**GENERATOR INTERCONNECTION
FEASIBILITY STUDY REPORT**

IPC PROJECT QUEUE #532

IDAHO POWER COMPANY ELECTRICAL SYSTEM

[REDACTED]
REPORT v.0

Figure 1 Operating requirements

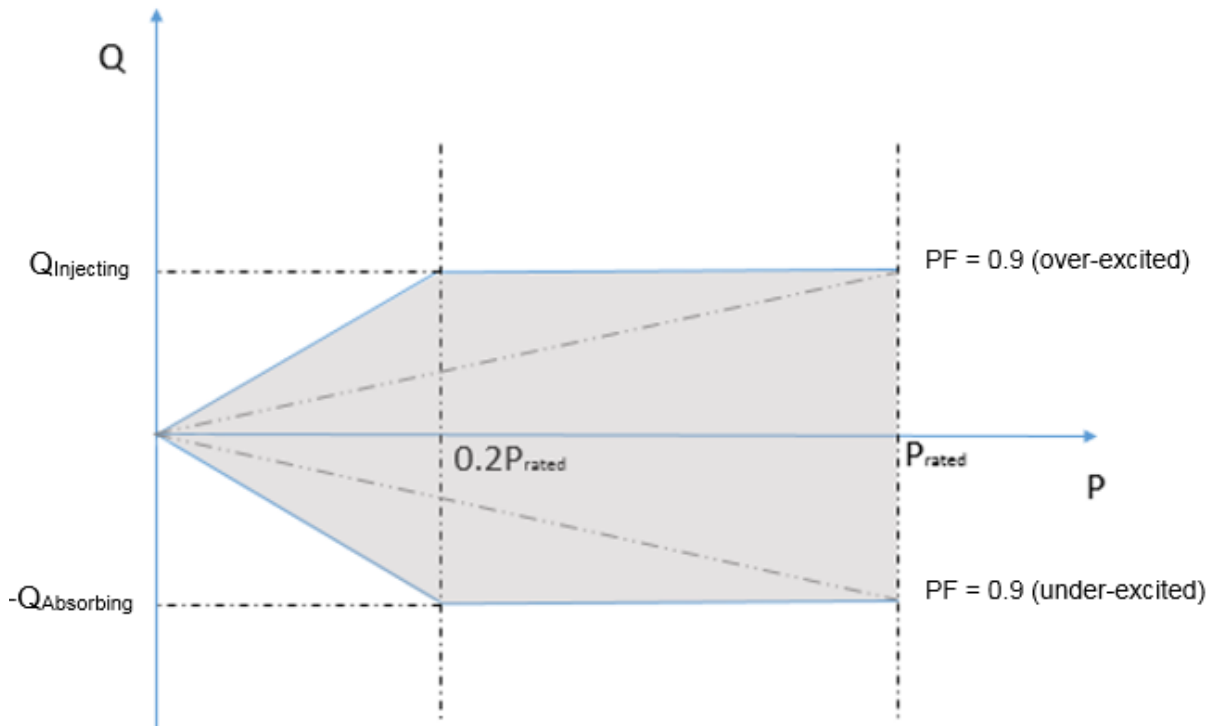
The Project shall be capable of injecting reactive power (over-excited) and absorbing reactive power (under-excited) equal to 1.452 MVAR at all active power output between 20% and 100% of nameplate active power rating.

Idaho Power has determined that the inverter selected by the Project does not meet the reactive power capability requirements. The inverter count will either need to be increased or the inverter kVA capability will need to be increased.

The Project will be required to control voltage in accordance with a voltage schedule as provided by Idaho Power Grid Operations. Therefore, GI #532 will be required to install a plant controller for managing the real and reactive power output of the 3 MW inverter array at the project POI. The installation of a PMU at the POI and maintenance costs associated with communication circuits needed to stream PMU data will also be required in order to interconnect GI #532.
